The Commission has issued the enclosed Amendments No. 20, 20, and 17 for Licenses No. DPR-38, DPR-47, and DPR-55, for the Oconee Nuclear Station, Units 1, 2, and 3. These amendments consist of changes to the Technical Specifications and are in response to your request dated December 1, 1975, as supplemented February 24 and 27, 1976.

OCONEE NUCLEAR STATION, UNIT 1

Amendment No. 20
License No. DPR-38

ATTACHMENT TO LICENSE AMENDMENTS

UNIT 1
OPERATIONAL POWER IMBALANCE
ENVELOPE FOR OPERATION FROM
0 TO 230 ± 5 EFPD
OCONEE NUCLEAR STATION
FIGURE 3.5.2-3A1

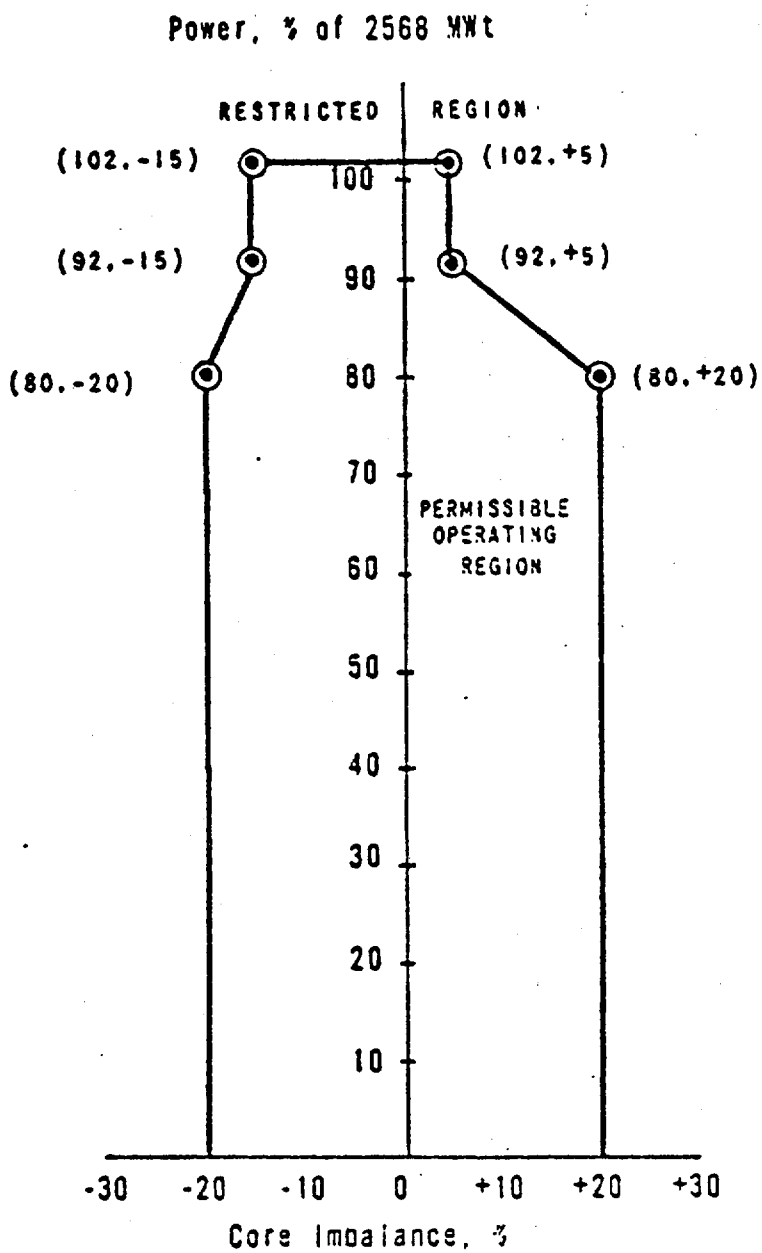
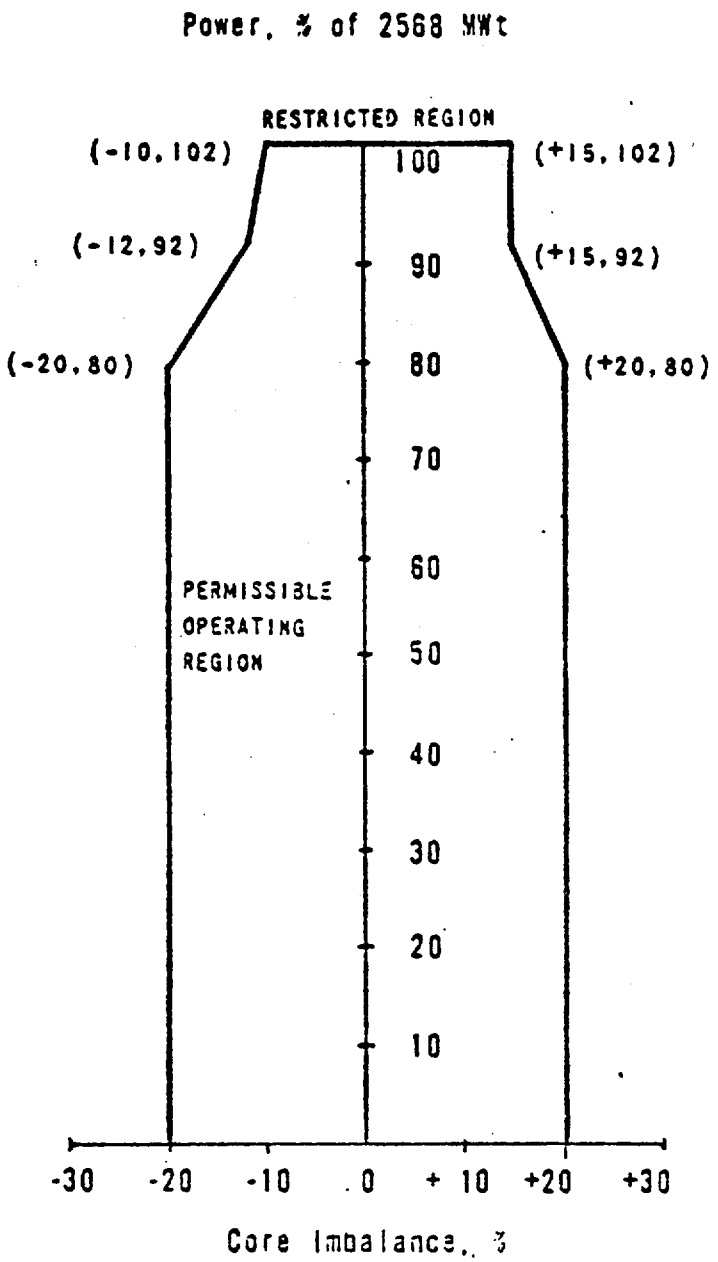
3.5.2.6 Reactor power imbalance shall be monitored on a frequency not to exceed two hours during power operation above 40 percent rated power. Except for physics tests, imbalance shall be maintained within the envelope defined by Figures 3.5.2-3A1, 3.5.2-3A2, 3.5.2-3B, and 3.5.2-3C. If the imbalance is not within the envelope defined by Figure 3.5.2-3A1, 3.5.2-3A2, 3.5.2-3B, and 3.5.2-3C, corrective measures shall be taken to achieve an acceptable imbalance. If an acceptable imbalance is not achieved within two hours, reactor power shall be reduced until imbalance limits are met.

The power-imbalance envelope defined in Figures 3.5.2-3A1, 3.5.2-3A2, 3.5.2-3B, and 3.5.2-3C is based on LOCA analyses which have defined the maximum linear heat rate (see Figure 3.5.2-4) such that the maximum clad temperature will not exceed the Final Acceptance Criteria. Corrective measures will be taken immediately should the indicated quadrant tilt, rod position, or imbalance be outside their specified boundary. Operation in a situation that would cause the Final Acceptance Criteria to be approached should a LOCA occur is highly improbable because all of the power distribution parameters (quadrant tilt, rod position, and imbalance) must be at their limits while simultaneously all other engineering and uncertainty factors are also at their limits.** Conservatism is introduced by application of:
